Periodic Bathymetry and Single Beam Surveys Report, 2012
Response to EPA Comments

2012 Sound Velocity Profiler Calibration

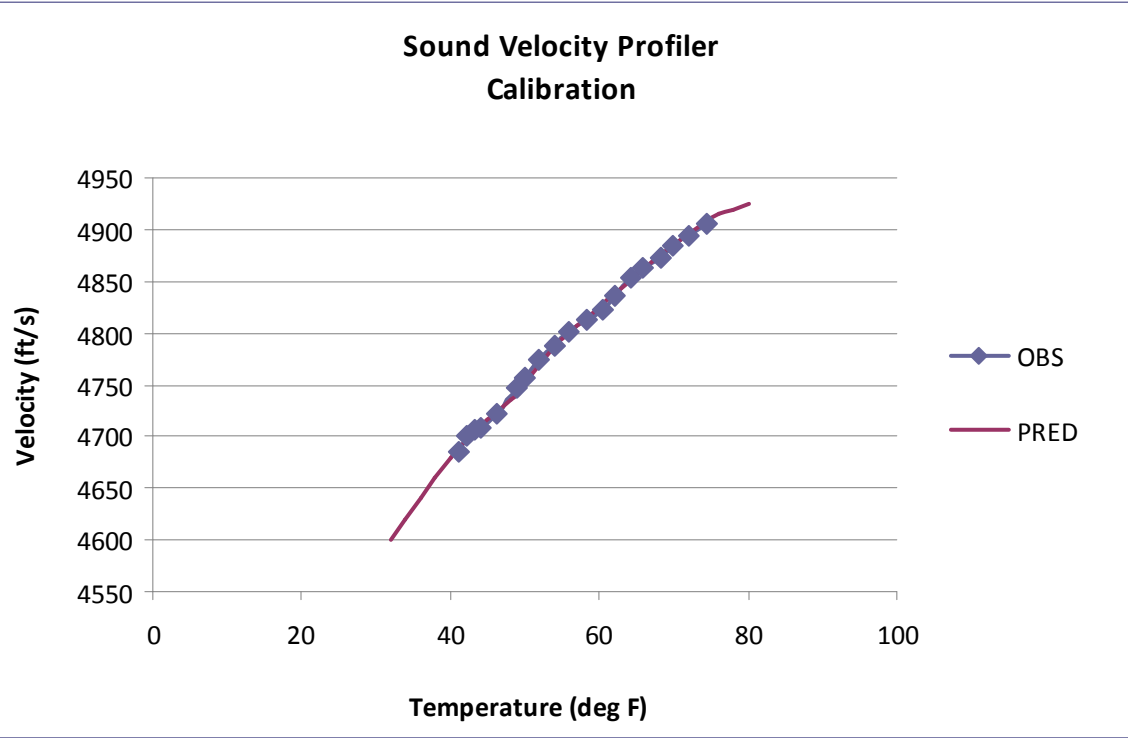
13	<i>GBA Single-beam Report, Section 5.0 QA/QC, Sound Velocity Profiles</i>	<p>It appears that the same sound velocity profiler calibration plot is being shown for the Fall 2012 multi-beam survey, Fall 2012 single-beam survey, Fall 2011 multibeam survey and Summer 2011 (RM 10.9) survey.</p> <ol style="list-style-type: none"> Please clarify since the text indicates that the SV profiler was calibrated prior to each survey Was the same SV profiler used for the Fall 2012 single-beam and multi-beam surveys? <ol style="list-style-type: none"> If so, how was that possible if the two surveys were occurring simultaneously? If not, were both SV profilers calibrated prior to the surveys? 	<p>Upon review we found that the 2011 graphic was mistakenly used in the 2012 report. An updated graphic and the Factory Calibration of the SV Profiler dated May 29, 2012 are provided in Attachment 1. The graphic was also added to the report as Figure 1.</p> <p>The SV profiler was only used for the multibeam survey. The SV profiler was not used for the single beam survey. The single beam was calibrated using bar checks. No edits were made to the report.</p>
